Further information request for resource consent application LU2000057 Landscape and Visual Matters – Revision 2 – clarification.

Marshall Day Acoustics Report

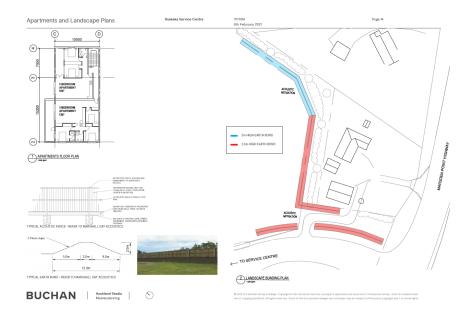
I acknowledge that a landscape architect is not suitably qualified to comment on the appropriateness of the noise (aside from sensory aspect), the query was really seeking commentary around the recommendations within the Marshall Day report which included fencing and bunds and if the mitigation measures contained within the LVA and associated plan sets were in accordance with the recommendations outlined in the Marshall Day report (in terms of the bund and fencing requirements) as this wasn't clear. If this can please be clarified.

The recommendations from the Marshall Day report have incorporated into the design. This is identified on Page 14 of the Buchan Architectural plan and includes the proposed earthbund and acoustic fencing (see image below). This information includes both cross sections and precedent photographs. The Boffa Miskell Planting Plan also includes these bunds / fencing and also identifies the proposed landscape treatment for these bunds. In addition to this an area of Native planting is included adjacent to the neighboring properties at 39 and 45 Port Marsden Highway. This planting includes a number of ground, mid level species and specimen trees (Nikau, Kowhai, Karaka, Pittosporum) (refer BML planting plan).
